ENGINEERING CHANGE NOTICE

Proj. ECN B-714-53

Block 5: B-714, GROUT VAULT PAIR (218-E-16-102 & 103)(218-E-16-104 & 105)/EDMC
Block 9: ECN B-714-17, B-714-22, B-714-30, B-714-42
Block 8: **AFFECTED DOCUMENTS (Drawings)**

13a. Justification (mark one)	13b. Justification Details
Criteria Change ■ Design Improvement ■ Environmental ☐ As-Found ☐ Facilitate Const. ■ Const. Error/Omission ☐ Design Error/Omission ■	CRITERIA CHANGE to separate Safety Class 2 & 3 wiring; ITEM #'s 6, 7, 17, 22, 23 & 34 (Ref WHC-SD-B714-W-QAPP-001, REV 4) ALL OTHER ITEMS are miscellaneous design improvements, drawing errors, design clarification and ease of construction changes.

KAISER ENGINEERS HANFORD	ENGINEERING CHANGE NOTICE SKETCH					
Ref. Dwg. ECN B-714-17	~~Sht.~~ P.7	~~Rev.~~	Prepared By A.R.SNOWHITE	Checked By C Dabletts	ECN No. B-714-53	Page 11/49

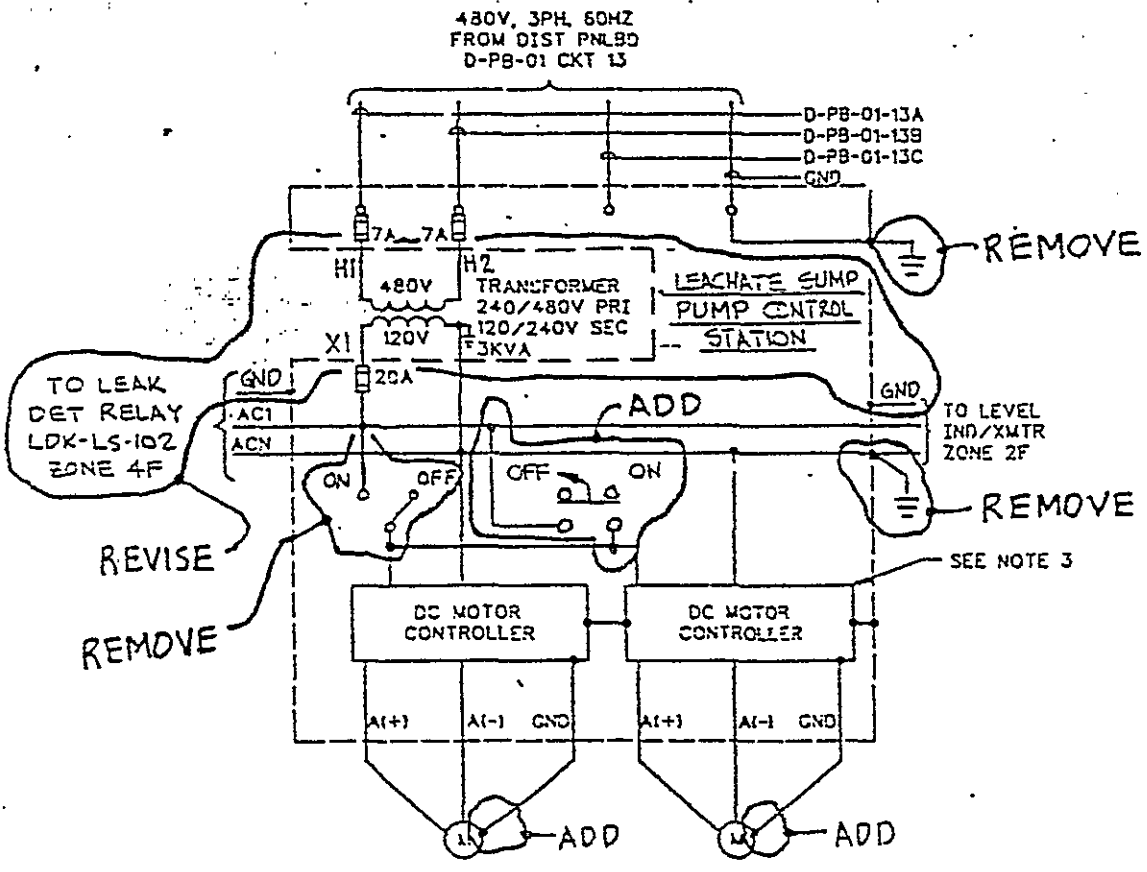
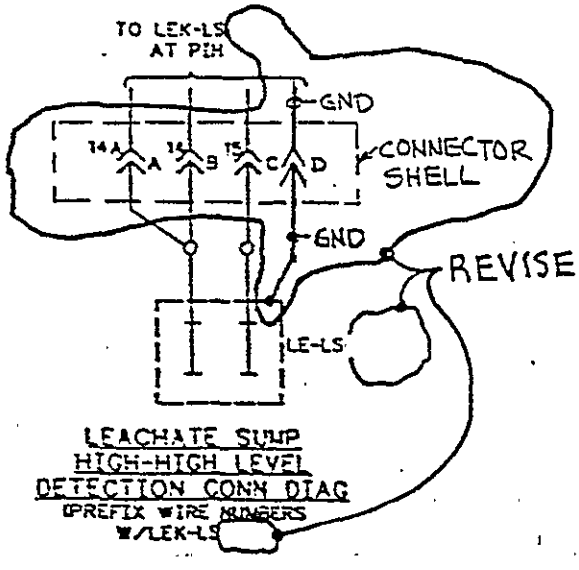
1) ECN B-714-17
   A) Replace pg 7 with page 11 of this ECN
   B) Replace pg 10 with page 12 of this ECN
   C) Replace pg 13 with page 13 of this ECN
   D) Replace pg 16 with page 14 of this ECN
   E) Page 24 - Delete Detail 2 from ECN
   F) Page 26, GWD111 thru GWD120: Delete ", SHLD" from WIRE NUMBERS column
   G) Replace pg 27 with page 15 of this ECN
   H) Replace pg 28 with page 16 of this ECN
   J) Page 29: • Modify MH103 ANNUNCIATOR TB as shown on page 17 of this ECN
      • Modify LEACHATE SUMP PUMP P-LS-103A & B MOTOR CONTROLLER as shown on page 18 of this ECN
      • Modify MH103 POWER TERM BOX as shown on page 18 of this ECN
   K) Page 30: • Modify LEACHATE SUMP PUMP P-LS-102A & B MOTOR CONTROLLER as shown on page 18 of this ECN
      • Modify MH102A POWER TERM BOX as shown on page 18 of this ECN
   L) Page 31: Modify - see page 19 & 20 of this ECN

KAISER ENGINEERS HANFORD	ENGINEERING CHANGE NOTICE SKETCH					
Ref. Dwg. ECN B-714-30	Sh. P7	~~Rev.~~	Prepared By A.R. SNOWHITE	Checked By	ECN No. B-714-53	Page 21/49

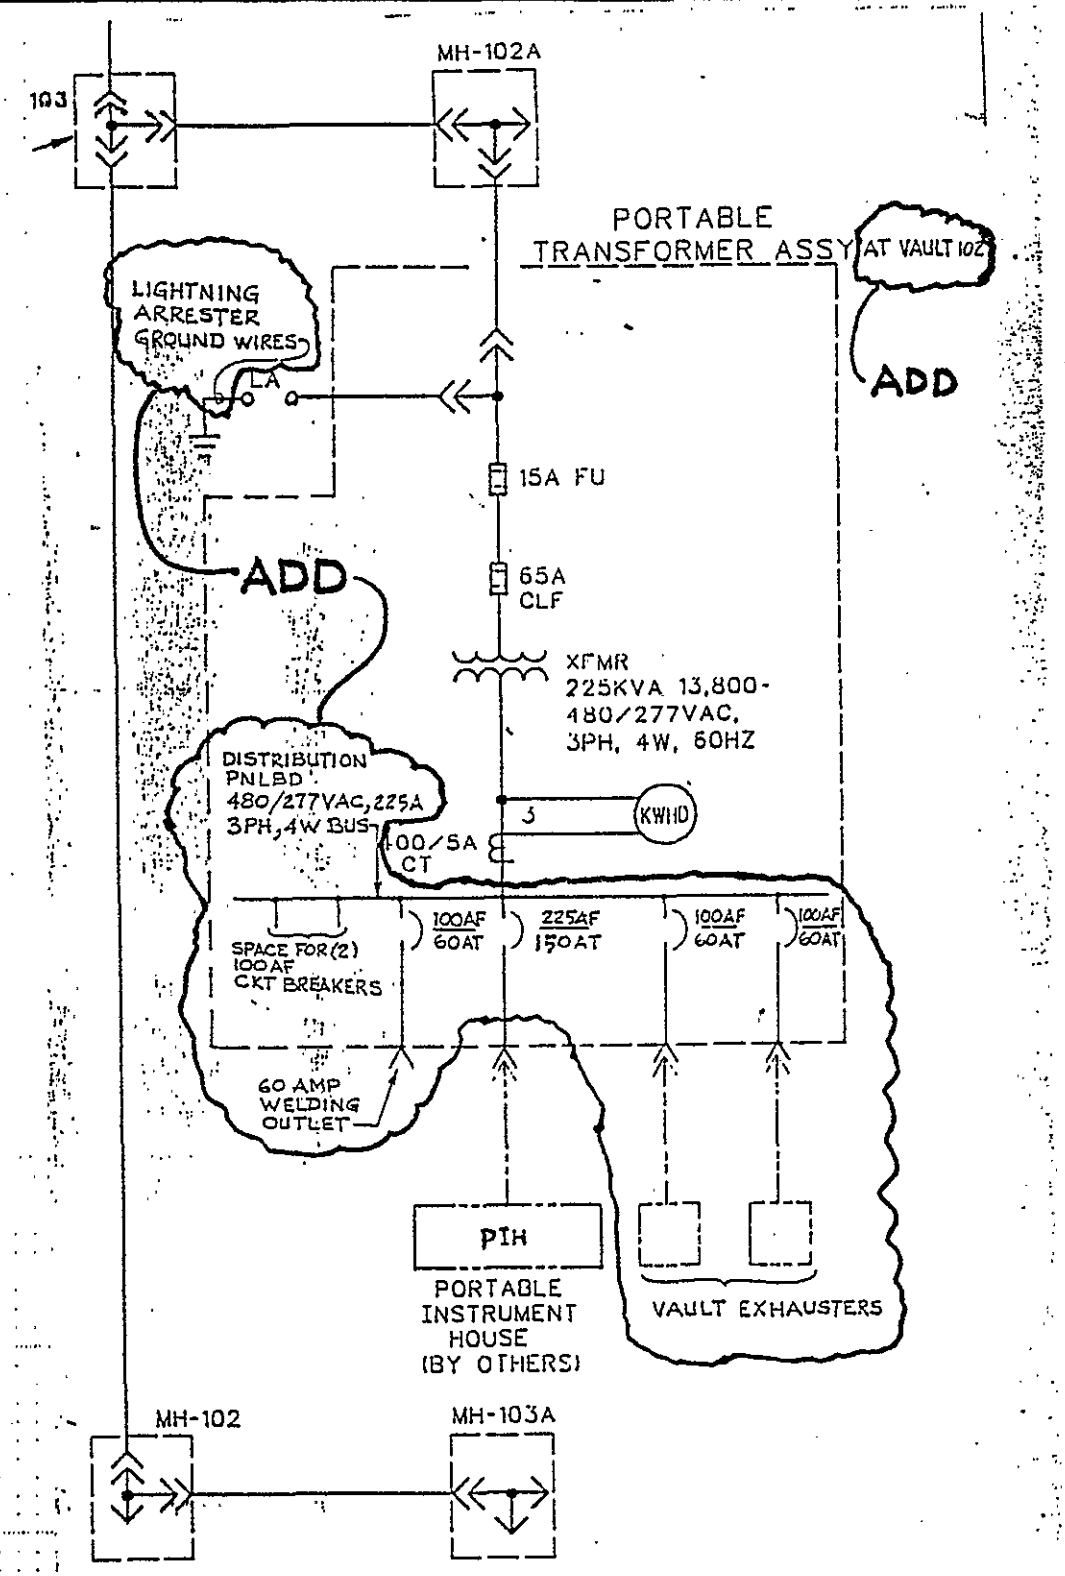
3) ECN B-714-30
   A) Page 3: Delete item 2E & 2F
   B) Replace pg 7 with page 21 of this ECN
   C) Replace pg 8 with page 22 of this ECN
   D) Replace pg 9 with page 23 of this ECN
   E) Replace pg 15 with page 24 of this ECN
   F) Replace pg 16 with page 25 of this ECN

KAISER ENGINEERS HANFORD	ENGINEERING CHANGE NOTICE SKETCH					
Ref. Dwg. H-2-77634	Sh. 1	Rev. 0	Prepared By A.R.SNOWHITE	Checked By	ECN No. B-714-53	Page 26/49

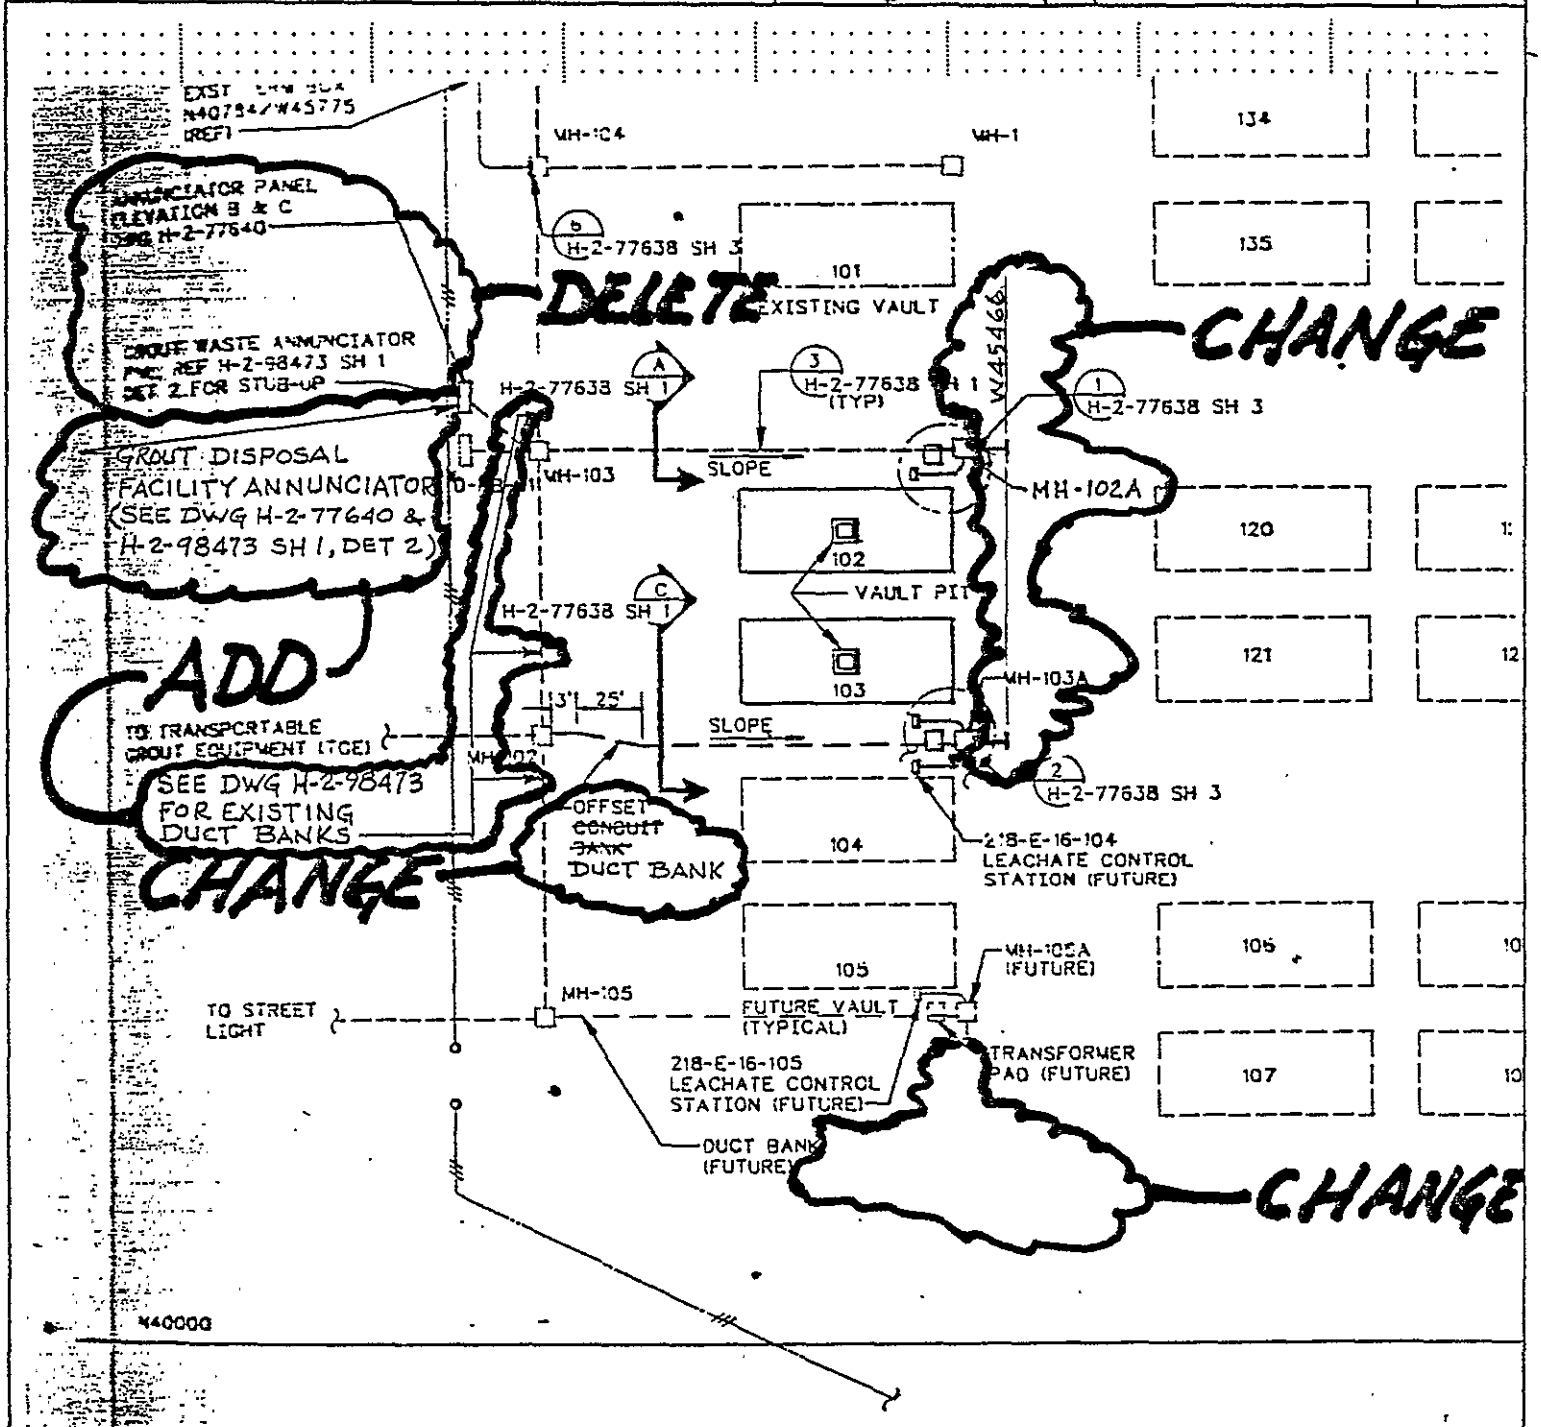
5) H-2-77634, SH 1, REV 0
   PLAN (ZE8, D8, D7, C6, D6): Modify - see page 26 of this ECN

KAISER ENGINEERS HANFORD	ENGINEERING CHANGE NOTICE SKETCH					
Ref. Dwg. H-2-77635	Sh. 1	Rev. 0	Prepared By A.R. SNOWHITE	Checked By	ECN No. B-714-53	Page 27/49

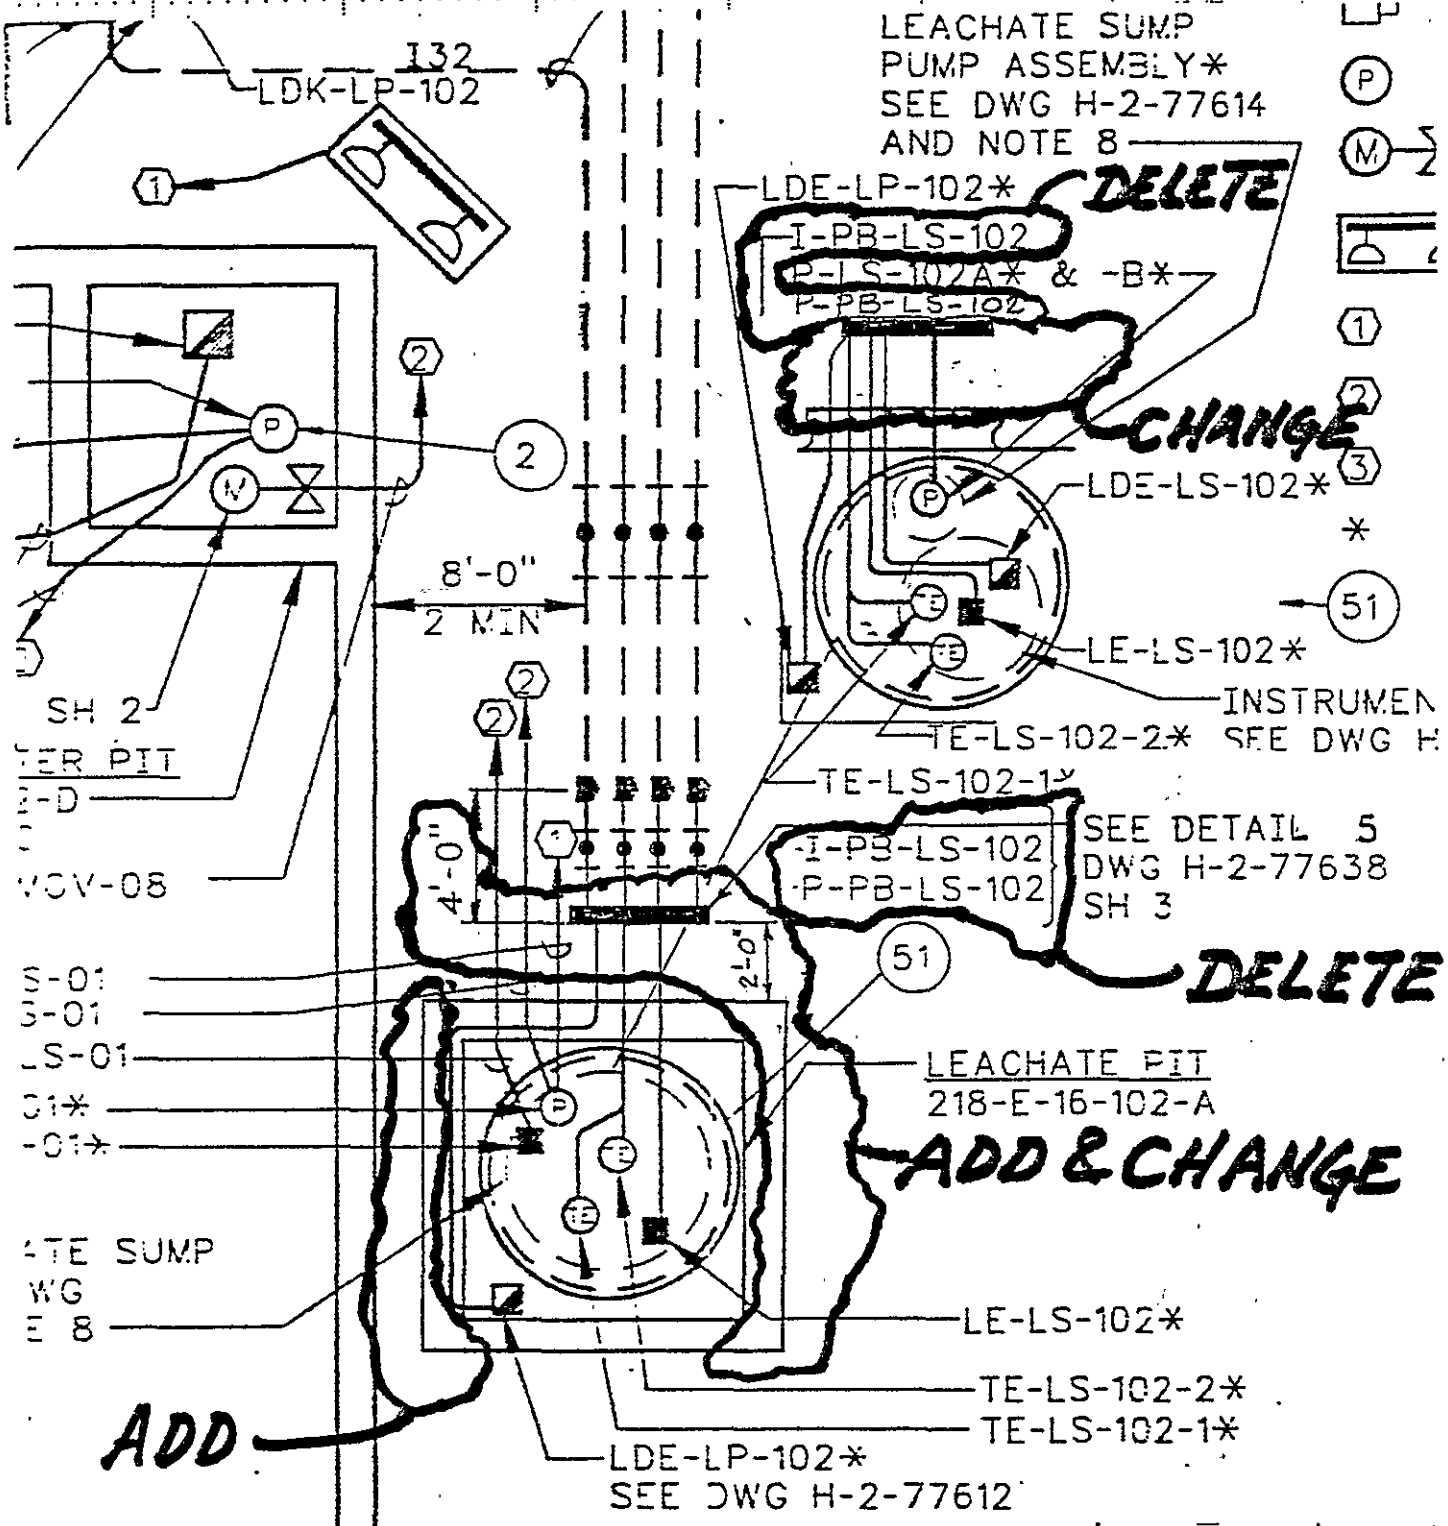
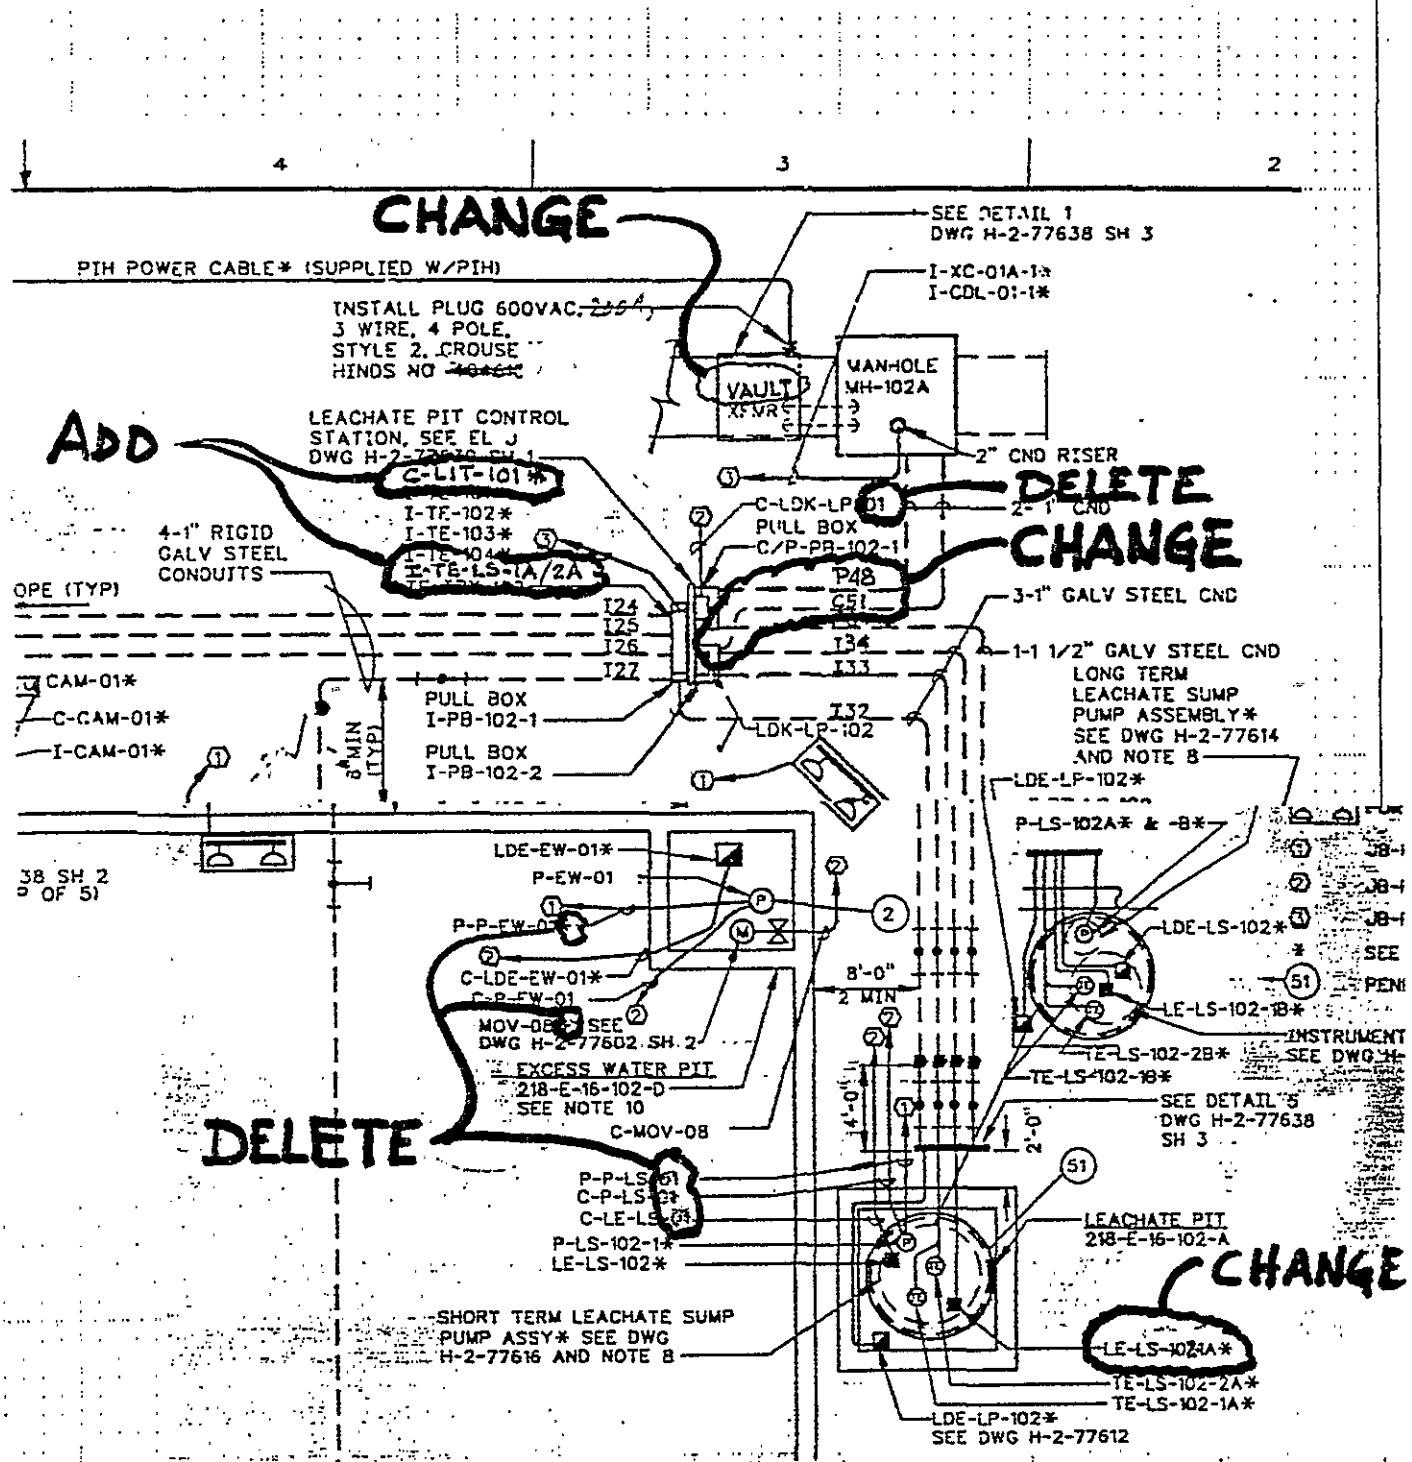
6) H-2-77635, SH 1, REV 0
   A) PLAN (ZD2-3, E2, F3): Modify - see page 27 & 28 of this ECN
   B) NOTE 9: Change "GRAVEL COCOON" to "DIFFUSION MATERIAL"
   C) (ZC3, C7, C8, E7): Add asterisk (*) to cable & pump numbers located at Excess Water Pits
